**BELLEVILLE COMBINED LICENSE APPLICATION – RESPONSE TO REQUEST FOR
ADDITIONAL INFORMATION – STABILITY OF SUBSURFACE MATERIALS AND
FOUNDATIONS**

Reference: Letter from Ravindra G. Joshi (NRC) to Andrea L. Sturgis (TVA), Request for
Additional Information Letter No. 101 Related to SRP Section 2.5.4 for the
Belleville Units 3 and 4 Combined License Application, dated August 5, 2008

Responses to NRC Request for Additional Information letter No. 101 dated August 5, 2008
(51 pages, including this list)

Subject: Stability of Subsurface Materials and Foundations as detailed in the Final Safety Analysis Report

Figure 13 taken from Reference 1
 Horizontal Pressure on Walls from Compaction Effort

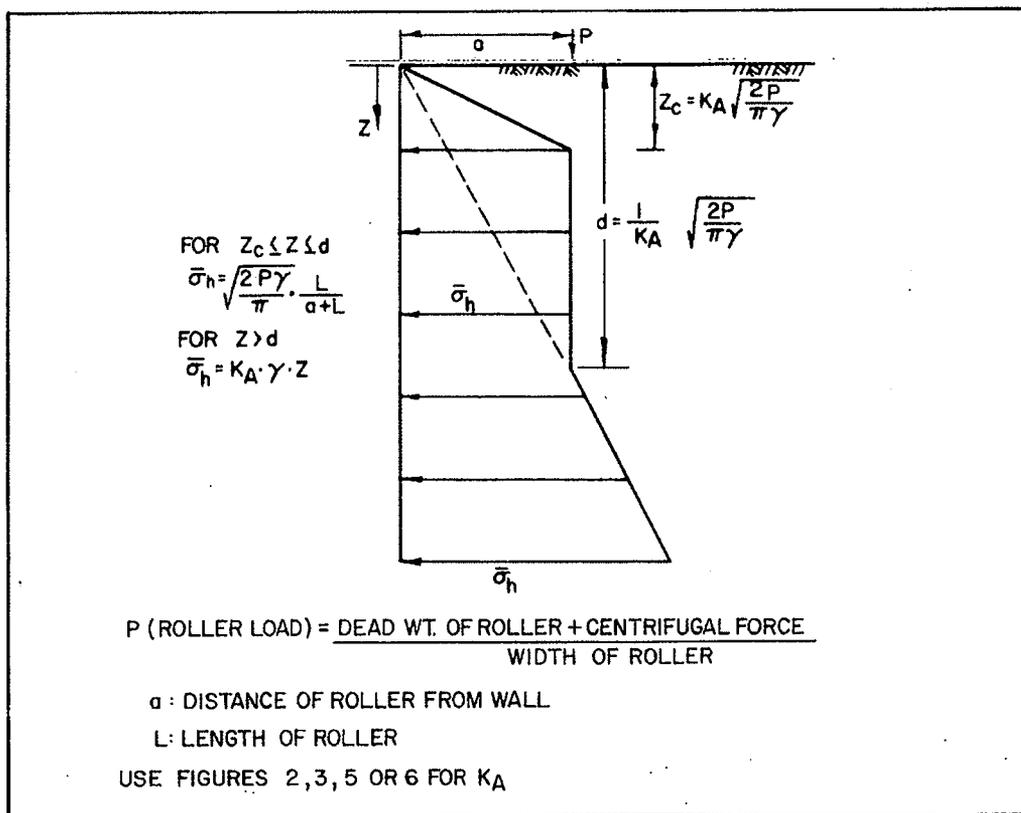
As requested in the RAI, compaction-induced loads acting on the exterior walls of the nuclear islands were evaluated. The added loads caused by compaction are a function of the weight of the compactor, the type (static or vibratory), the distance it is operated from the wall and the soil types. A method for evaluating the lateral earth pressures on a wall due to the earth and the compaction equipment is given in Figure 13 of NAVFAC DM 7.2 (Reference 1). A copy of the referenced figure is included in Attachment 02.05.04-14A. Another method for calculating the lateral earth pressures to incorporate stresses from compaction is presented in a paper by Duncan et al. (Reference 2). A comparison of both methods found that the NAVFAC method yields slightly higher pressures for the same distance from the wall, so the NAVFAC method was used for the evaluation.

A summary of typical self-propelled drum compactors is contained in Reference 2. Review of the listed compactors shows the one producing the greatest total force is a Dynapac Model CA30 with a total force of 70.6 kips, a drum width of 84 inches and a wheelbase of 113 inches. Using the NAVFAC methodology, stresses for this compactor operating at distances from the wall varying from 1 foot to 5 feet were compared to stresses calculated at the same depth using the static at-rest earth pressure calculated from FSAR Figure 2.5-360, assuming no water table is present. The comparison showed that keeping the compactor at least five feet away from the wall, as is stated in FSAR Subsection 2.5.4.10.5,

will keep stresses on the wall due to the compaction equipment at a negligible level. Therefore, no adjustment to the recommended lateral earth pressure for static, at-rest conditions is needed. FSAR Figure 2.5-360 does not need revision in response to this RAI.

Revised Figure 2.5.4-360

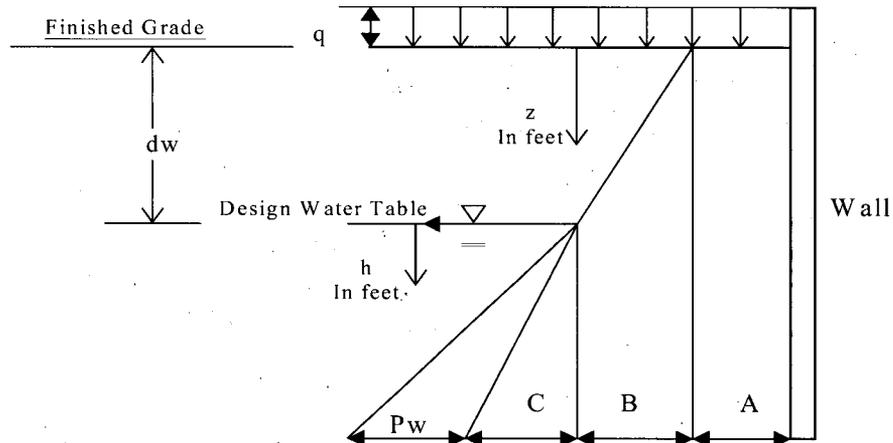
FSAR Section 2.5.4.10.5 states that the earth pressure coefficients for the at-rest and passive conditions determined using the methods described in Reference 462 are illustrated in FSAR Figures 2.5-360 and 2.5-361. FSAR Figure 2.5-360 shows the distribution of earth pressures from the soil backfill (at-rest condition), and, below the water table, the additional pressure caused by the hydrostatic pressure. FSAR Figure 2.5-361 shows the soil passive pressure distribution. No hydrostatic pressure is included in the passive pressure because water has no shear strength and provides no additional passive resistance. Since the hydrostatic associated pressure also contributes to the lateral pressure applied to the nuclear island walls, excluding the hydrostatic pressure from the passive, at-rest, or active earth pressure evaluation is not justified. Please include the hydrostatic pressure into passive or at-rest earth pressure evaluation and revise the contents of FSAR Figs. 2.5-360 and 2.5-361, accordingly.

Discussions with NRC technical staff have clarified that inclusion of the hydrostatic pressure in the at-rest and passive earth pressure diagrams is appropriate for the nuclear island basement walls. The FSAR text and Figures 2.5.4-360 and 2.5.4-361 will be revised as described below in a future revision of the COLA.

Earth pressure coefficients for the at-rest and passive conditions determined using the methods described in Reference 462 are illustrated in Figures 2.5-360 and 2.5-361. Figure 2.5-360 shows the distribution of earth pressure from the soil backfill (at-rest condition), and, below the water table, the additional pressure caused by hydrostatic pressure. Figure 2.5-361 shows the soil passive earth pressure distribution, including the additional pressure caused by hydrostatic pressure below the water table.

2. COLA Part 2, FSAR Chapter 2, Figure 2.5.4-360 will be revised as indicated in Attachment 02.05.04-21A.
